# **SCOPING OPINION:**

## **Proposed SDC M40 Campus**

**Case Reference: EN0110030**

Adopted by the Planning Inspectorate (on behalf of the Secretary of State)  
pursuant to Regulation 10 of The Infrastructure Planning (Environmental  
Impact Assessment) Regulations 2017

Figure 11 Levels of Significance for Landscape and Visual Effects<sup>190</sup>

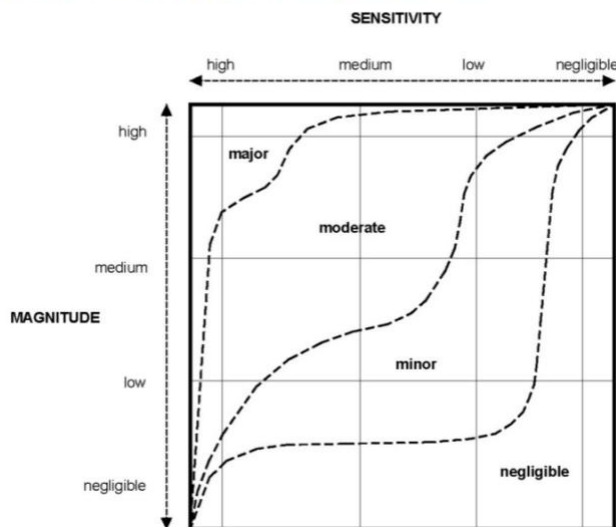
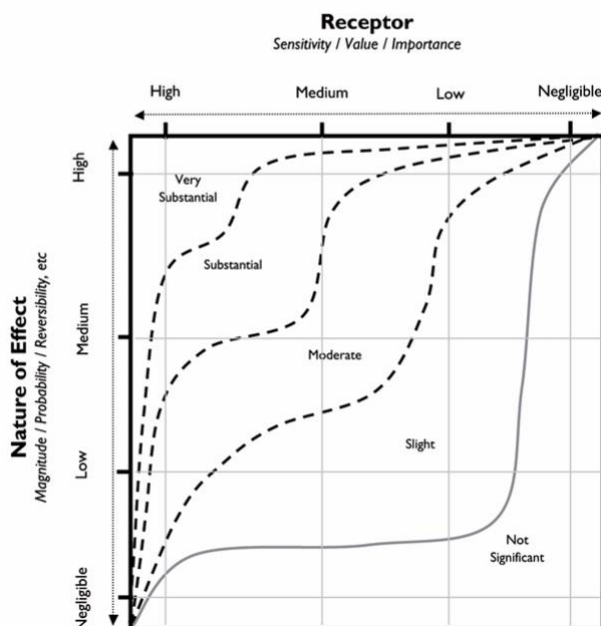
127. The Council do not agree with use of the applicant's proposed significance matrix, presented as this and stating it is based on a matrix published by the IEMA:

128. The Council has considered the original figure published by the IEMA in 'The State of Environmental Impact Assessment in the UK' 2011, which presents the following figure:

129. It is clearly evident that the applicant has simply merged effects of 'substantial' significance with those of 'moderate' significance. There's no explanation as to why this has been done. The result is it downplays the significance of effects that might otherwise be assessed as 'substantial' according to the IEMA matrix. It also indicates that that only the very worst effects (high magnitude of change in a highly sensitive landscape/view) are likely to be considered major in the applicant's matrix. This approach lacks balance, and notwithstanding the applicant's statement that both major and moderate effects will be considered significant, there is an important perceptual difference between moderate and major effects.

36.10	Figure 11	Determining effect significance	The applicant's attention is drawn to Buckinghamshire Council's comments (appendix 2 of this Opinion) regarding the proposal to determine effect significance using the matrix at Figure 11. The ES should use the original EIA significance evaluation matrix in IEMA's guidance The State of EIA in the UK (2011), or it should otherwise justify using the altered version in the Scoping Report and explain how it has ensured that concluded effects have not been downplayed or underreported.
